**ADDENDUM NO. 1 TO BID DOCUMENTS FOR THE
EAST MUD LAKE HYDROLOGIC RESTORATION
PROJECT (CS-20) - FINAL MAINTENANCE**

CAMERON PARISH, LOUISIANA

**STATE OF LOUISIANA
COASTAL PROTECTION AND RESTORATION AUTHORITY**

June 18, 2018

Structure #17 - Asbuilts

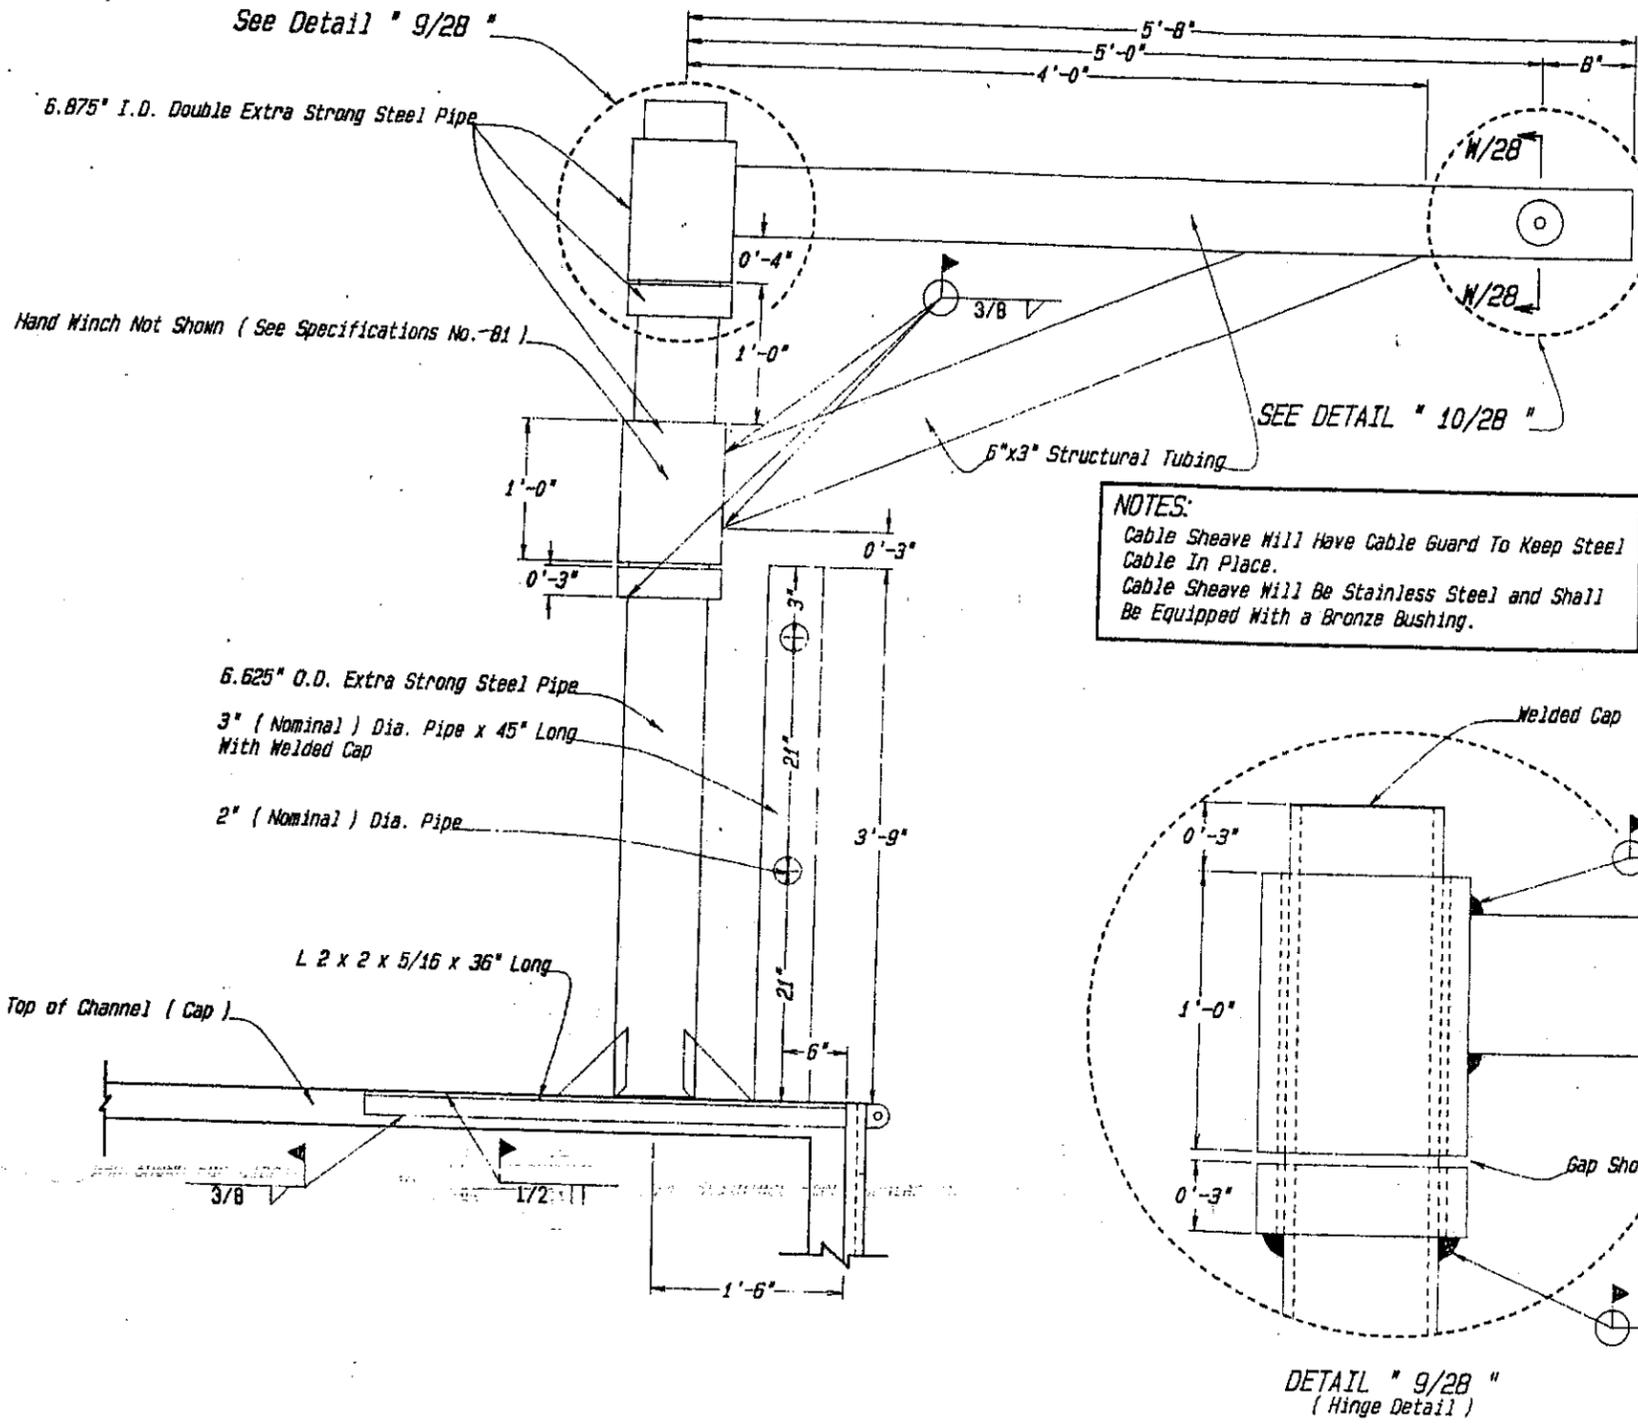
1. Question: Can you provide the construction drawings or as-built drawings for the existing Structure No. 17 for the purpose of aiding in the estimating of demolition of the structure?

Response: See attached drawings.

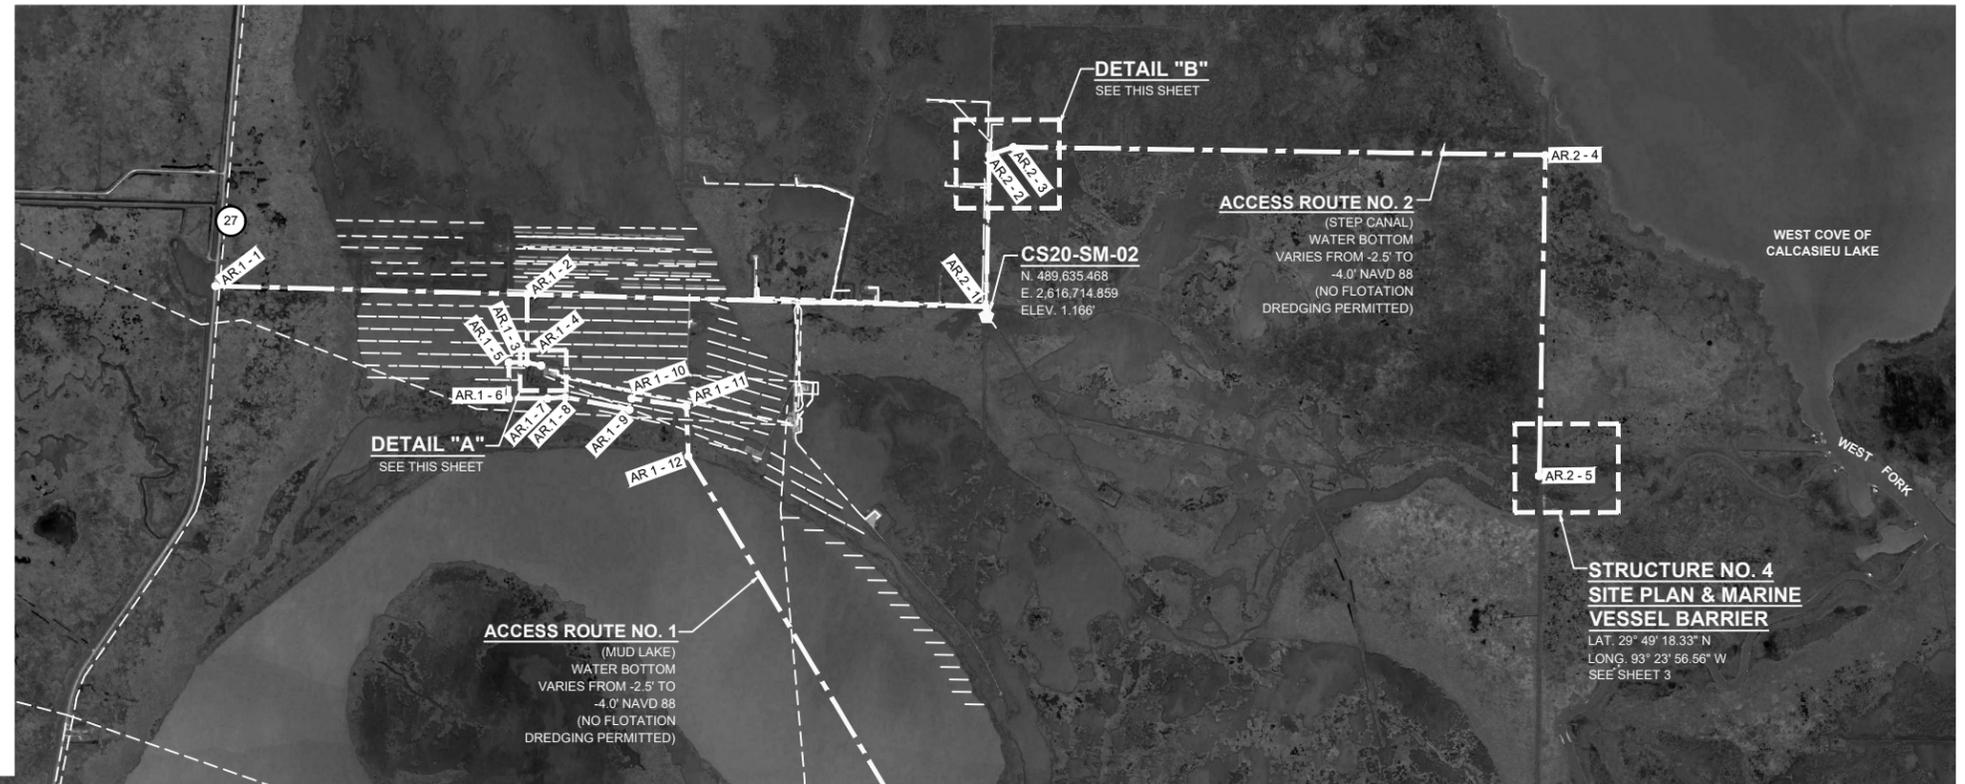
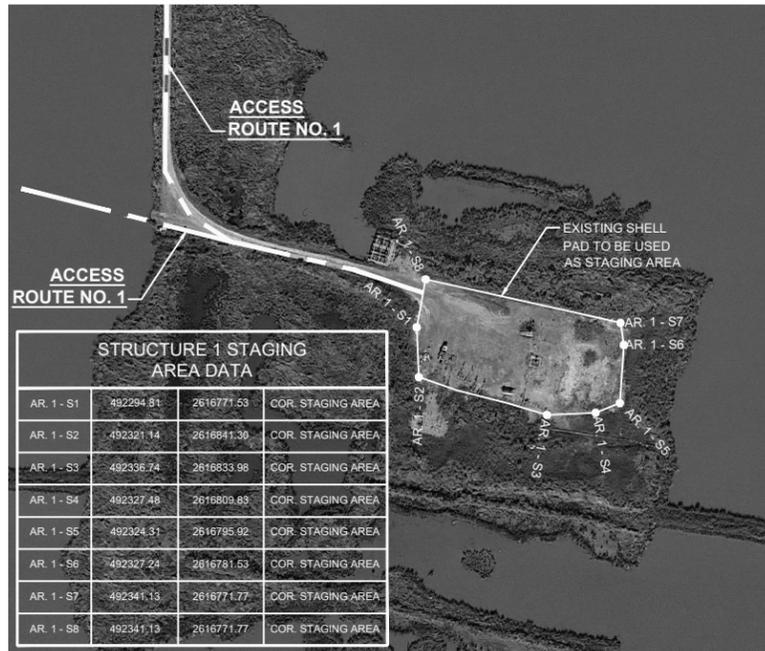
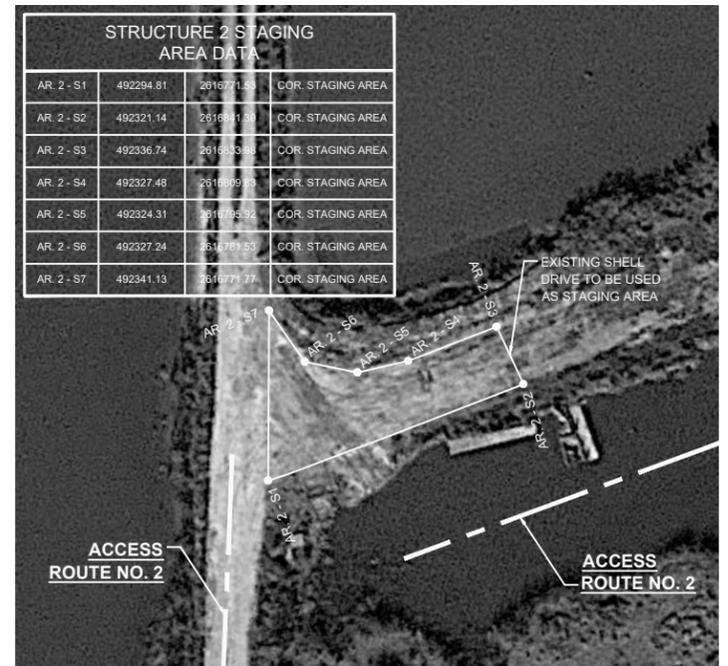
2. Will there be any restrictions placed on the contractor for work being performed during the waterfowl seasons?

Response: The use of airboats is highly discouraged and conditional permission must be given for their use. Surface drive or shallow draft outboards should be used throughout construction. If the use of airboats is an absolute necessity, permission can be granted upon review and consideration by the land owner on a case-by-case basis. The use of airboats is prohibited during waterfowl season prior to 10:00 am and after 3:00 pm. All vessels shall adhere to the access routes provided in the project drawings.

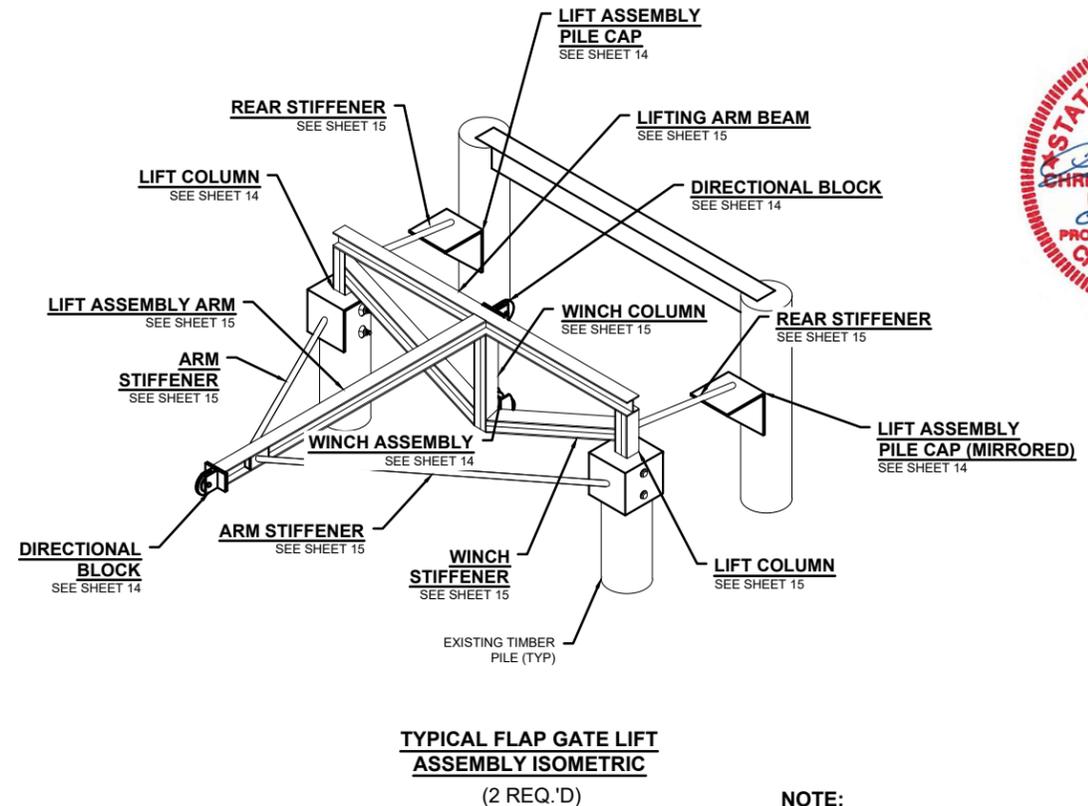
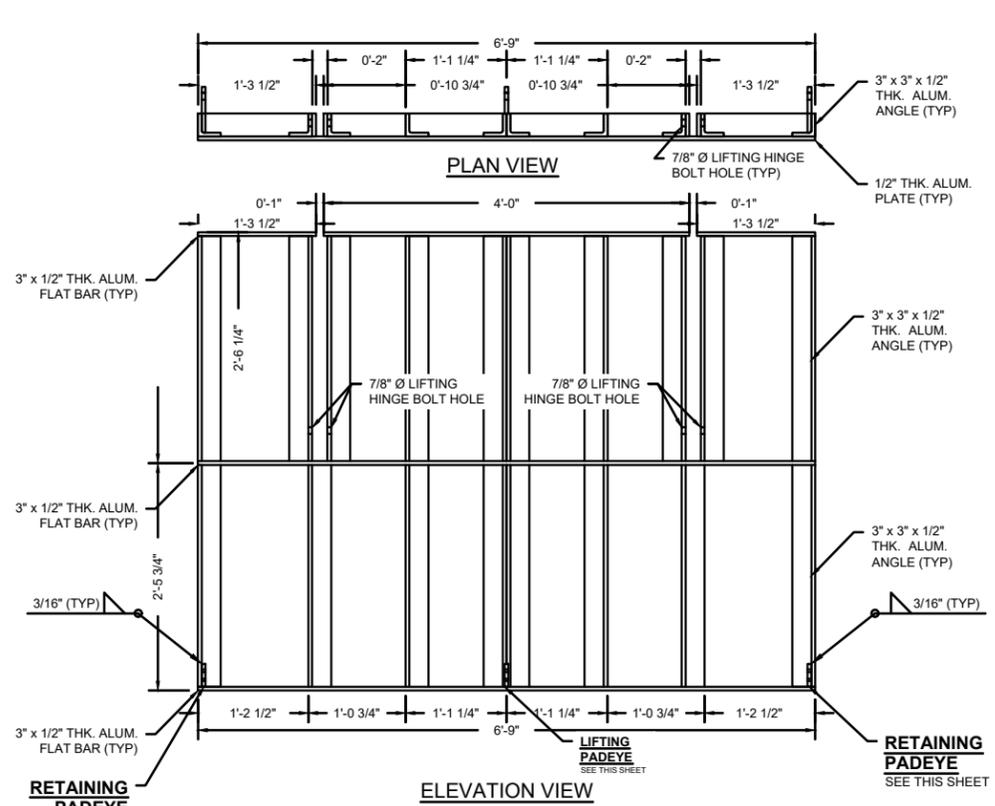
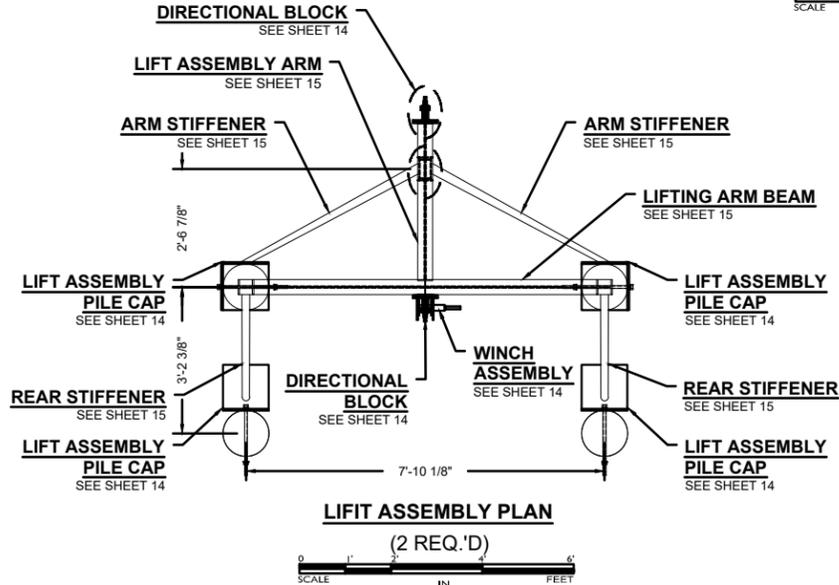
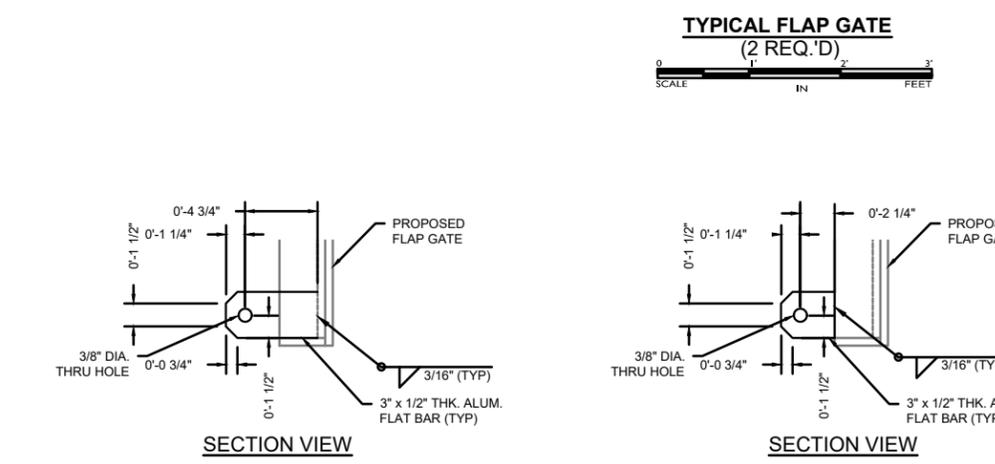
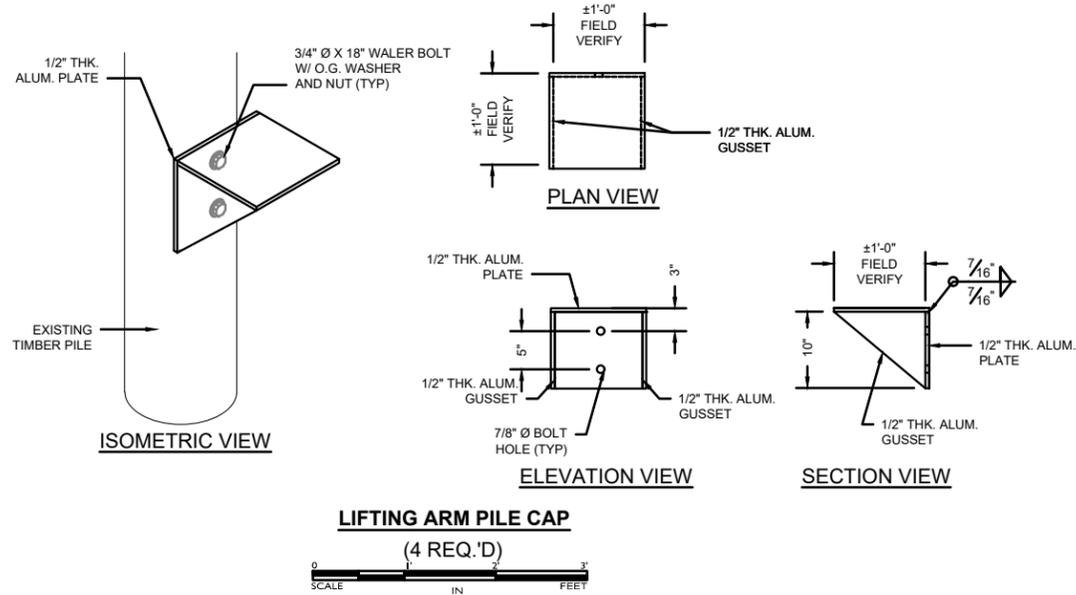
4. When will new drawings be available for the redesign of the lifting arm to be installed on Structure #13?

Response: Revised drawings are attached.
